City of Portsmouth  
Department of Public Works

Bid Proposal #30-06  
Shoreline Repairs Prescott Park and Four Tree Island  
**Addendum #1**  
**January 27, 2006**

This Addendum forms part of the original document marked Bid #30-06 Shoreline Repairs Prescott Park and Four Tree Island:

**PRESCOTT PARK SITE PLAN**

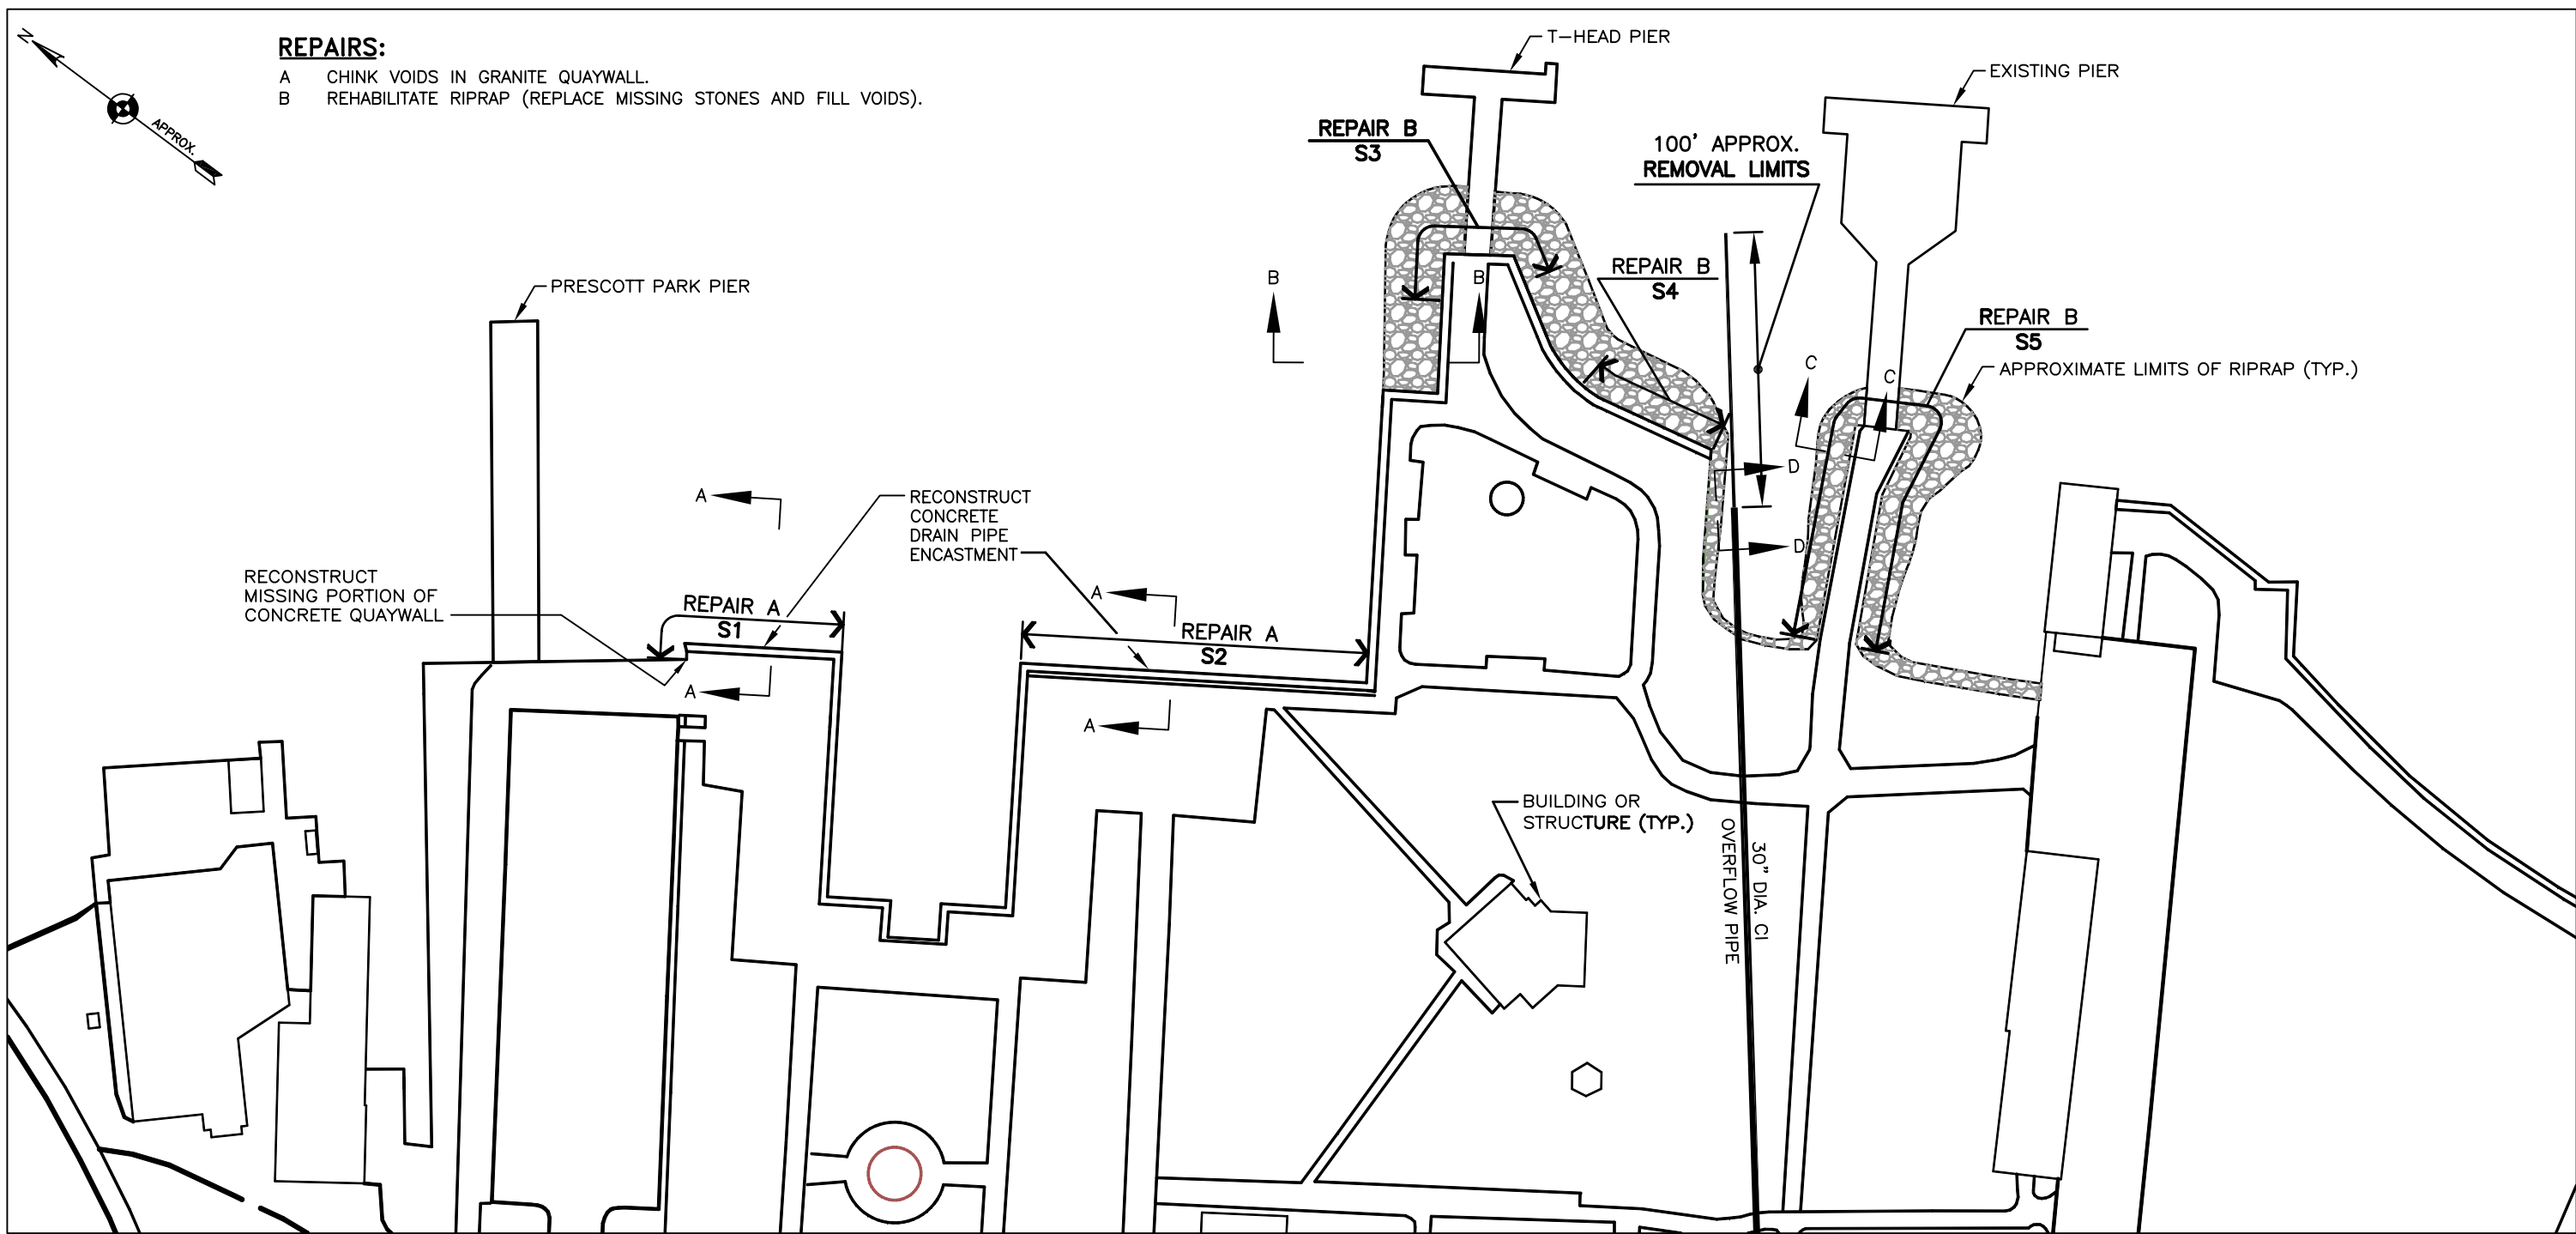
Alternate #1 Drain Line Modifications:

There is an old drain line extending into the river between T-Head Pier and the Existing Pier. This pipe consists of small sections of 30" Cast Iron pipe and is essentially lying on the river bottom. The proposed modifications consist of the following:

1. Excavate old 30" CI drain pipe from where it exits the ground at approximately mid-tide level to its termination near the end of the existing pier. (Approximately 100 LF)
2. This new termination shall be slip-lined with a 27" PVC pipe and mortared in place for a minimum length of 10'. Contractor to confirm the pipe size.
3. Rip Rap Class A shall be placed around the new out-fall to stabilize the structure in accordance with the Standard Details Sheet 2 of 3 entitled Prescott Park Sections.
